Date: 2004-09-03

Engineering Change Order – Class I

New Machine Layout in IR3 and IR7

Figure 1: Sketch of the LHC secondary collimator, including dimensions.

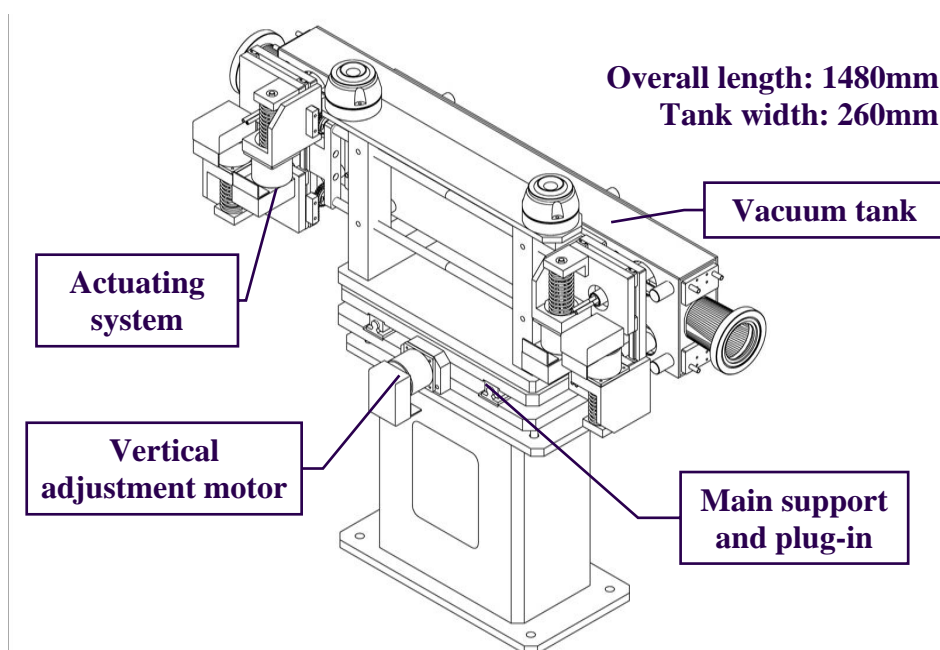
A detailed engineering design was started and the flange-to-flange length of a tank for secondary collimator was fixed to **1.480 m**.
